Evaluation Kit for RA2E1 Microcontroller Group
EK-RA2E1 v1
Errata

Renesas RA Family
RA2 Series

This Errata describes the known issues and exceptions to the functional specifications for the EK-RA2E1 v1, Evaluation Kit for the RA2E1 MCU Group. For additional information on the kit, see the EK-RA2E1 v1 user's manual.

Figure 2. MCU VCL Pin Capacitor Incorrect Value

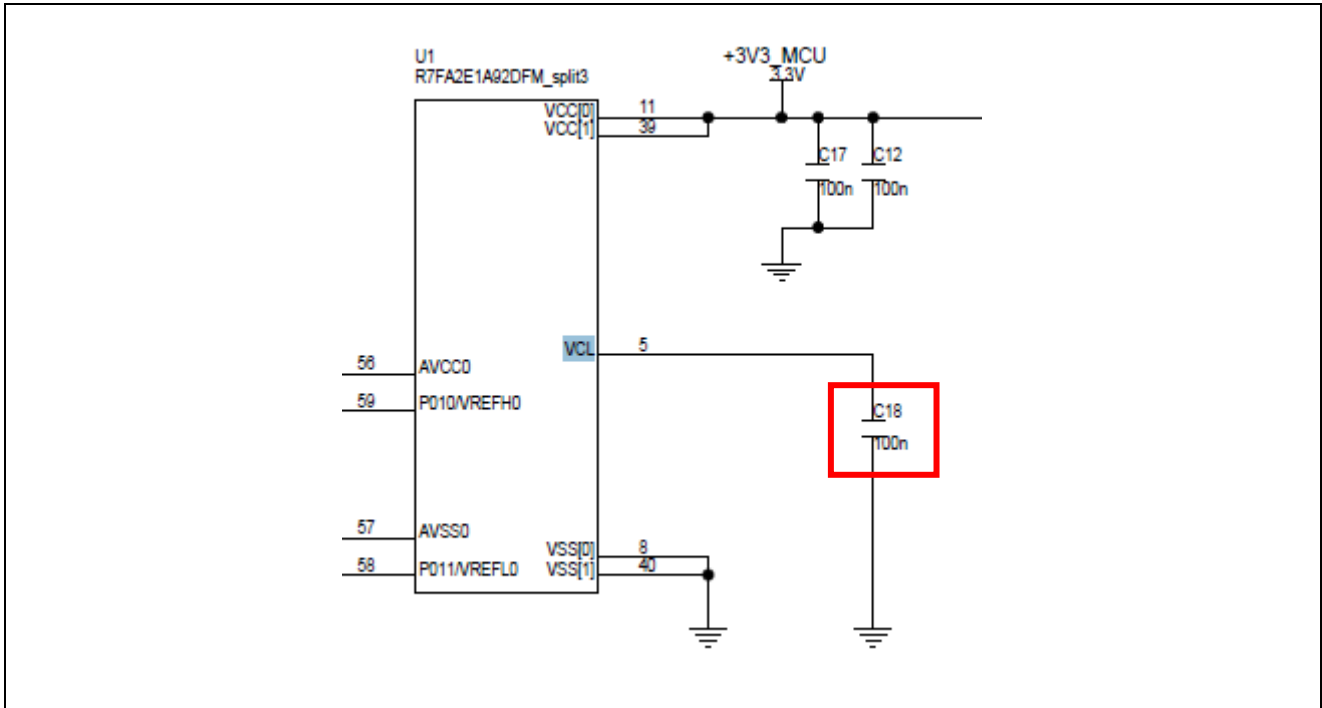
The VCL pin is used for stabilization of the MCU’s internal operating voltage. The RA2E1 MCU hardware manual specifies that the VCL pin be connected to VSS using a 4.7 μF multilayer ceramic capacitor placed physically close to the pin. In earlier builds of the EK-RA2E1 board this capacitor (C18) has an incorrect value of 0.1 μF (100 nF).

It is recommended that you replace this capacitor with one with the correct value and type if mis-operation occurs when switching between low power and full power modes.

Figure 3. MCU Pin Header J2 Pin 8 Silkscreen Error

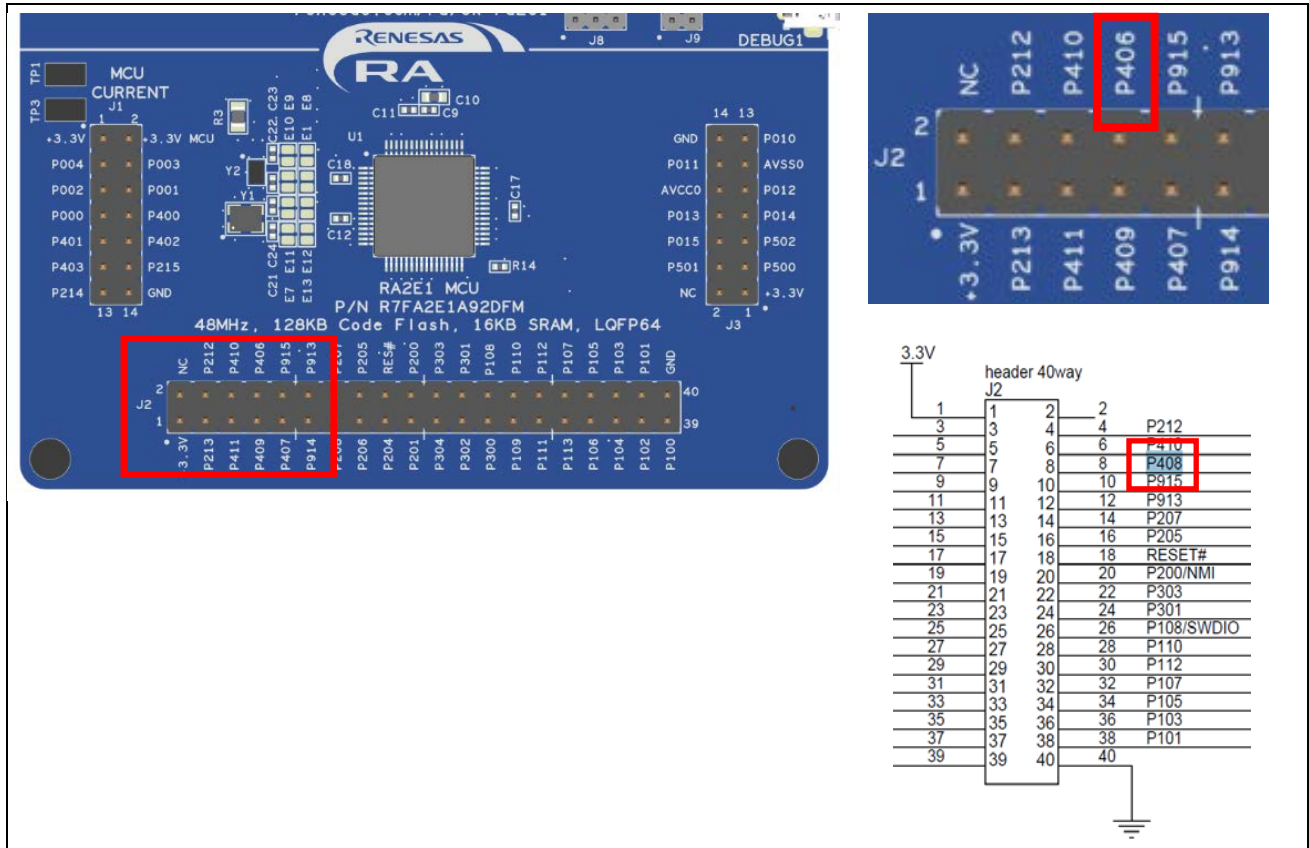
The MCU Pin Header J2 has an incorrect label for pin 8. This is identified as P406 when it should be P408. The schematic is correct.

None. The silkscreen has been corrected to show the correct pin identification on later builds of the board.
